ND-19-1031
10 CFR 50.90

Southern Nuclear Operating Company
Vogtle Electric Generating Plant Unit 4
Request for License Amendment:
Reinforcement Changes for Wall L and Wall 7.3 (LAR-19-016)

Enclosure 1

Request for License Amendment: Reinforcement Changes for Wall L and Wall 7.3
(LAR-19-016)

Figure 1: Typical #11 Rebar Configuration for Wall L

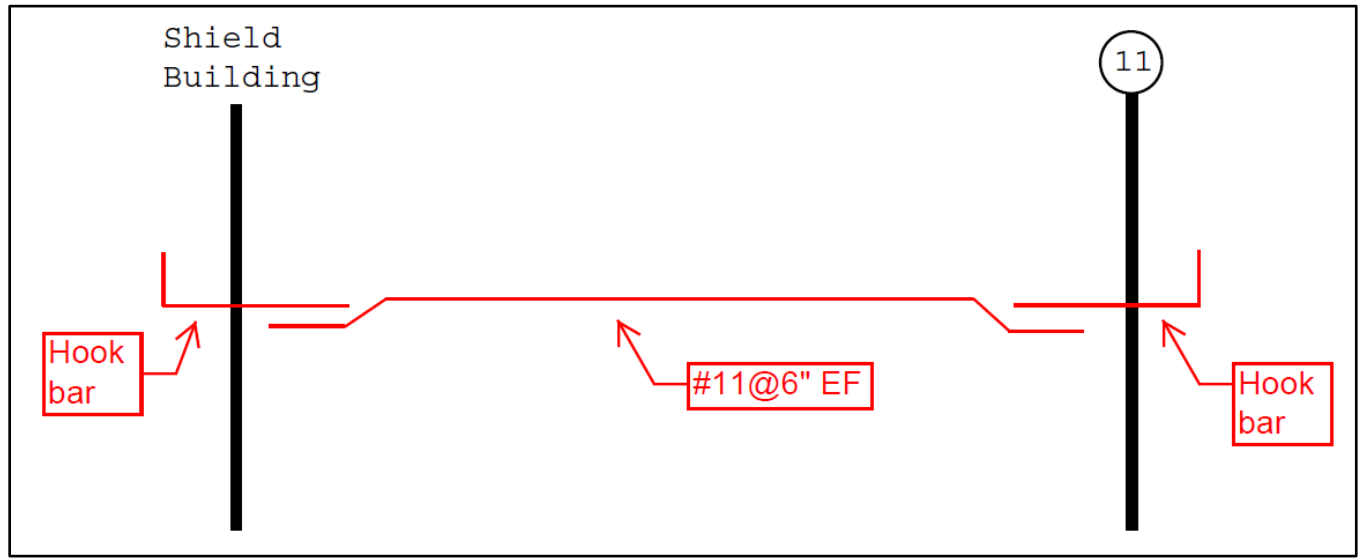
One horizontal reinforcement bar #11 (EF) located directly above EL. 117'-6" is omitted from VEGP Unit 4 Wall L (EL. 117'-6" to EL. 135'-3"). All other horizontal reinforcement bars, #11@6" EF + #10@12" EF between EL. 117'-6" and EL. 135'-3" remain unchanged and are installed as required by the design, including one row directly above the omitted row consisting of both a #11 and #10 bar EF. The 36 standard hook bar (or U-Bar) dowels EF installed into Wall 11 remain unchanged and are developed within Wall L as required by the design.

A simplified sketch of the typical #11 rebar configuration is shown in Figure 1 (#10@12" not shown). A simplified sketch of the proposed change, applicable to the single omitted #11(EF), is shown in Figure 2.

As clarified by Figure 2, the single #11 (EF) is not developed for the entire width of Wall L. Therefore, this bar is unable to be credited as provided reinforcement. This results in the as-built provided amount of horizontal reinforcement area being less than the current UFSAR Table 3H.5-7 Wall Section 2 (Elevation 135'-3" to 117'-6") provided minimum value of 4.39 in²/ft; the actual provided value is 4.36 in²/ft. This condition results in the provided horizontal reinforcement area

Figure 4: Proposed Rebar Configuration directly below EL. 135'-3\"/>

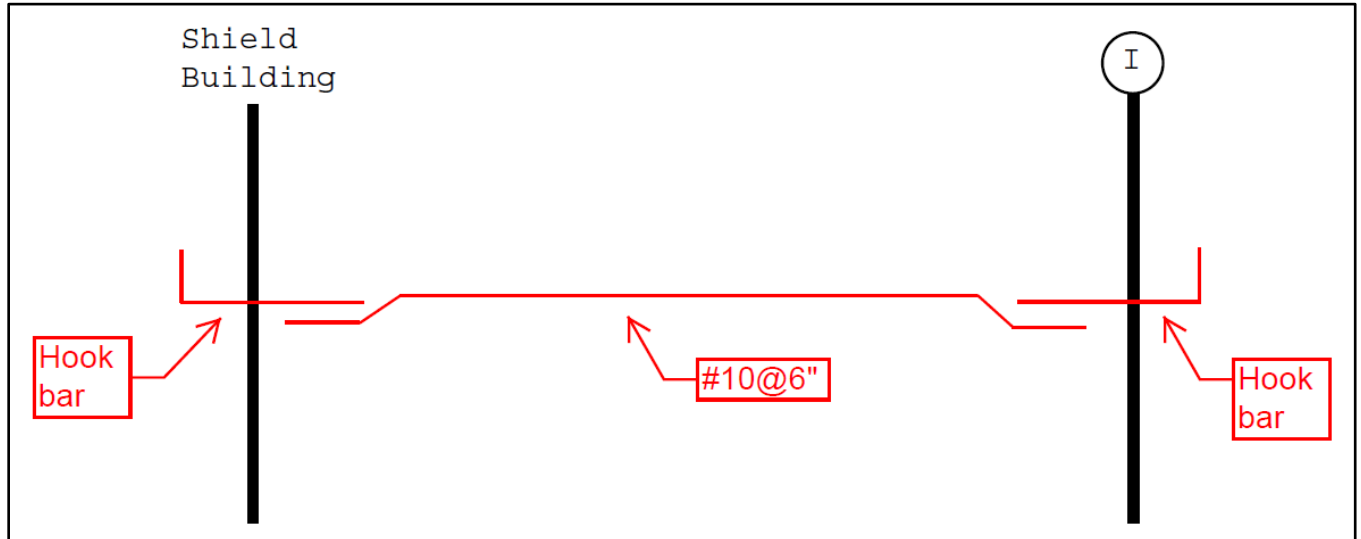
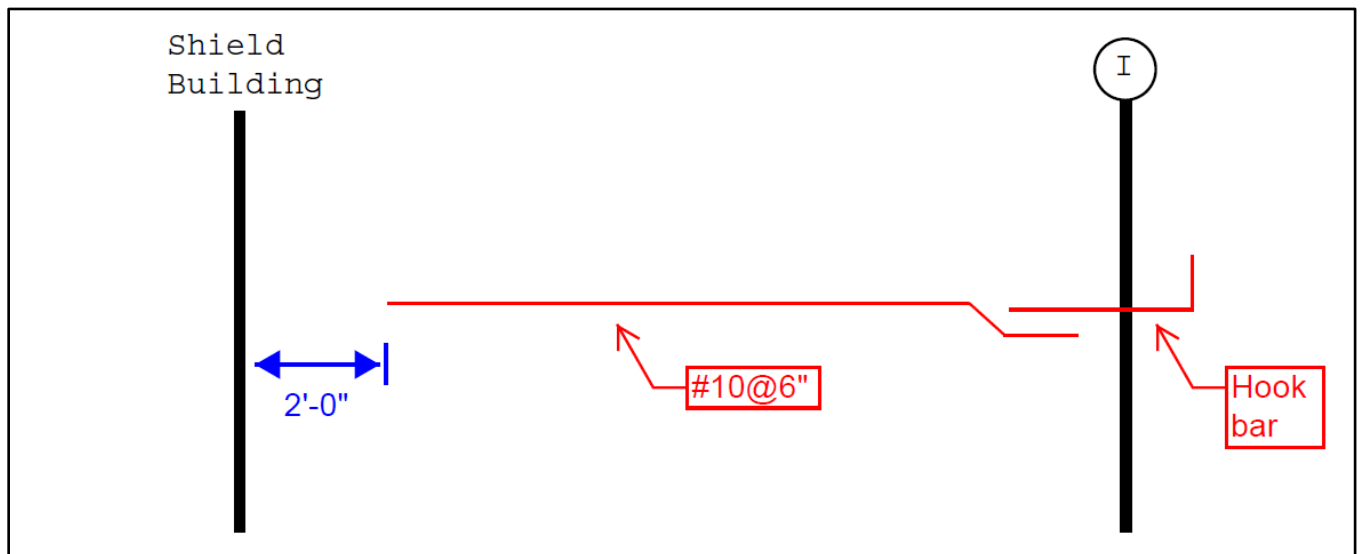
One horizontal reinforcement bar #10 (EF) located directly below EL. 135'-3" is to be spliced to standard hook bar (EF) in Wall I and extend to 2'-0" from the Shield Building. The associated #10 (EF) dowel developed into the Shield Building is not installed.

A simplified sketch of the typical #10 rebar configuration is shown in Figure 3. A simplified sketch of the proposed change for one horizontal reinforcement bar #10 (EF) located directly below EL. 135'-3" is shown in Figure 4.

As clarified by Figure 4, the single #10 (EF) is not developed for the entire width of Wall 7.3. Therefore, this bar is unable to be credited as provided reinforcement. This results in the as-built provided amount of horizontal reinforcement area being less than the existing UFSAR Table 3H.5-5 Wall Section 3 (Elevation 117'-6" to 135'-3") provided minimum value of 2.54 in²/ft. The actual provided value is 2.50 in²/ft for this segment of Wall 7.3. This condition results in the

Figure 5 - Wall L FEA Critical Element and Impacted Elements

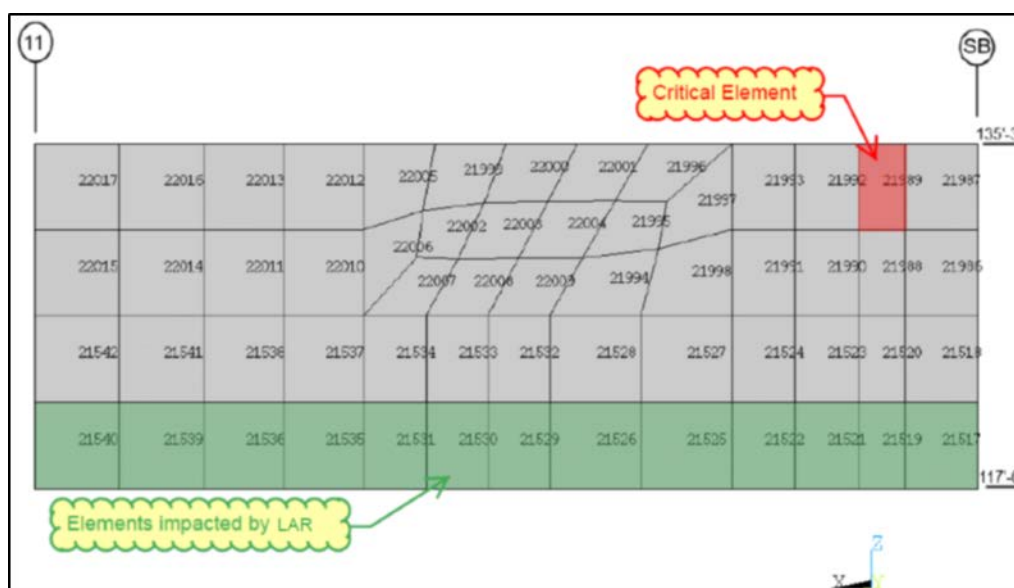
The documented design margin for Wall L (EL. 117'-6" to EL. 135'-3") is 66.7% based on the critical element. The elements impacted by the proposed change are not located near the critical elements as shown in Figure 5 and have a revised margin of 73.7% considering the subject reduction in area of provided reinforcement presented in this LAR. Therefore, the proposed change does not reduce the design margin for Wall L.

Considering the subject reduction in area of provided horizontal reinforcement presented in this LAR, the maximum calculated interaction ratio of the local impacted elements is $IR_{Local}=0.26$. Since the IR remains less than 1.0, the proposed change is acceptable and continues to satisfy the acceptance criteria of ACI 349-01 and applicable design criteria. Furthermore, the IR_{Local} is less than the documented critical element interaction ratio.

Figure 6 - Wall 7.3 FEA Critical Element and Impacted Elements

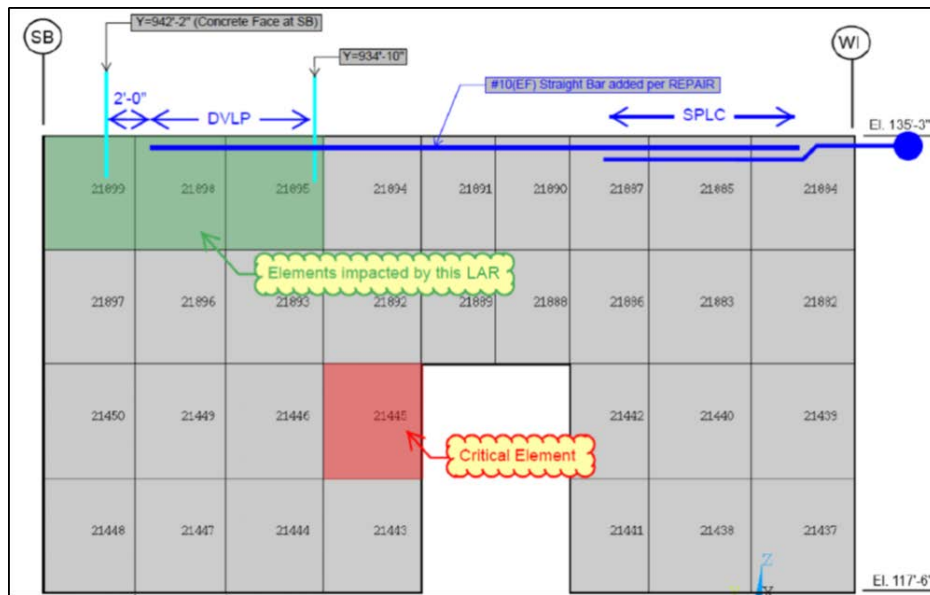
The documented design margin for Wall 7.3 (EL. 117'-6" to EL. 135'-3") is 17.2% based on the critical element. The elements impacted by the proposed change are not located near the critical elements as shown in Figure 6 and have a margin of 17.86% considering the subject reduction in area of provided reinforcement presented in this LAR. Therefore, the proposed change does not reduce the design margin for Wall 7.3.

Considering the subject reduction in area of provided horizontal reinforcement presented in this LAR, the calculated interaction ratio of the local impacted elements is $IR_{Local}=0.82$. Since the IR remains less than 1.0, the proposed change is acceptable and continues to satisfy the acceptance criteria of ACI 349-01 and applicable design criteria. Furthermore, the IR_{Local} is less than the documented critical element interaction ratio.

Revise UFSAR Figure 3H.5-4, “Typical Reinforcement in Wall 7.3” as shown below:

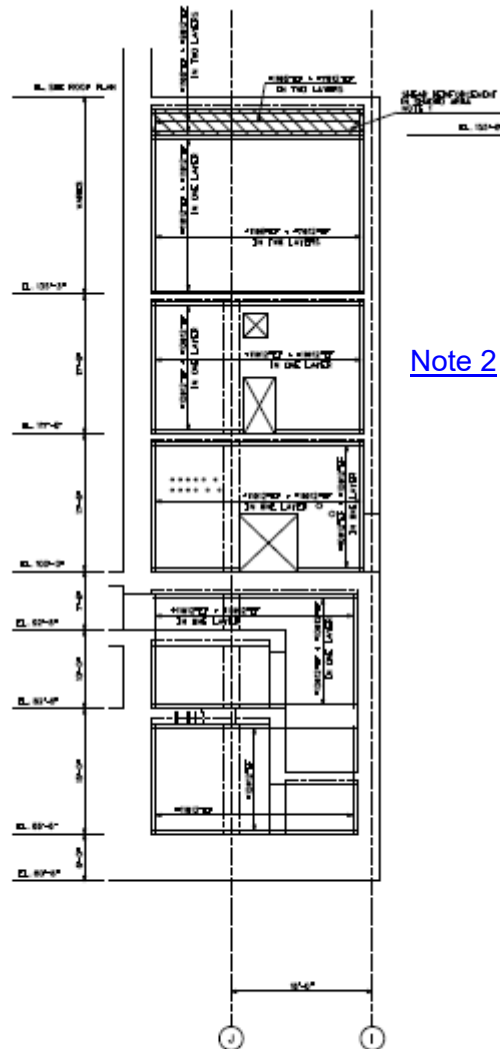
Additionally, changes are proposed to UFSAR Figure 3H.5-4 because the figure shows #10@6" horizontal rebar with the full development length between EL. 117'-6" and 135'-3". Because a single #10 (EF) is not developed for the entire width of Wall 7.3, a note is added to UFSAR Figure 3H.5-4 to explain the configuration change for VEGP Unit 4.

- UFSAR Figure 3H.5-4: A note is added to describe that two #10 horizontal reinforcement bars (one on each face) are terminated 2'-0" from the shield building vertical construction joint, directly below 135'-3" for VEGP Unit 4. The note references UFSAR Table 3H.5-5 for additional detail.

NOTE 2:

FOR VOGTLE UNIT 4, TWO HORIZONTAL REINFORCEMENT BARS ARE TERMINATED 2'-0" FROM THE SHIELD BUILDING VERTICAL CONSTRUCTION JOINT. THESE BARS, ONE #10 ON EACH FACE OF THE WALL, ARE LOCATED DIRECTLY BELOW ELEVATION 135'-3". SEE TABLE 3H.5-5 FOR ADDITIONAL DETAILS.

Revise UFSAR Figure 3H.5-12, “Typical Reinforcement in Wall L” as shown below:

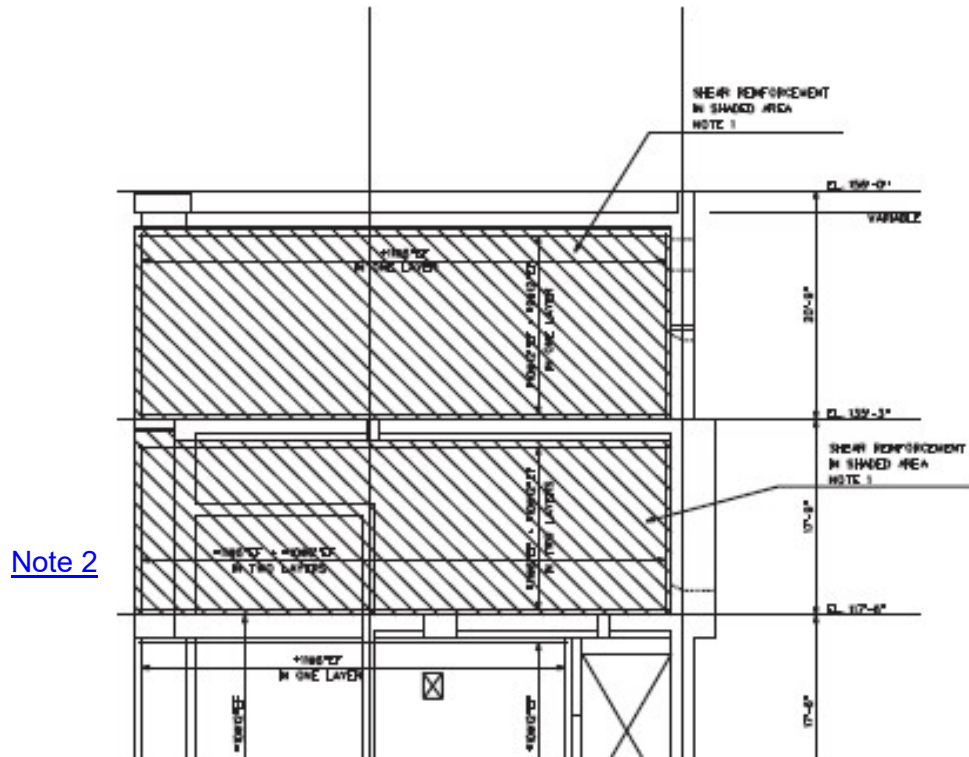
Additionally, changes are proposed to UFSAR Figure 3H.5-12 because the figure shows #11@6" EF horizontal rebar with the full development length between EL. 117'-6" and 135'-3". Because a single #11 (EF) is not developed for the entire width of Wall L, a note is added to UFSAR Figure 3H.5-12 to explain the configuration change for VEGP Unit 4.

- UFSAR Figure 3H.5-12: A note is added to describe that two #11 horizontal reinforcement bars (one on each face) are omitted directly above 117'-6" for VEGP Unit 4. The note references Table 3H.5-7 for additional detail.

NOTE 2:

**FOR VOGTLE UNIT 4, TWO #11 HORIZONTAL REINFORCEMENT
BARS (ONE ON EACH FACE) ARE OMITTED DIRECTLY ABOVE
ELEVATION 117'-6", FOR THE ENTIRE WIDTH OF THE WALL. SEE
TABLE 3H.5-7 FOR ADDITIONAL DETAILS.**
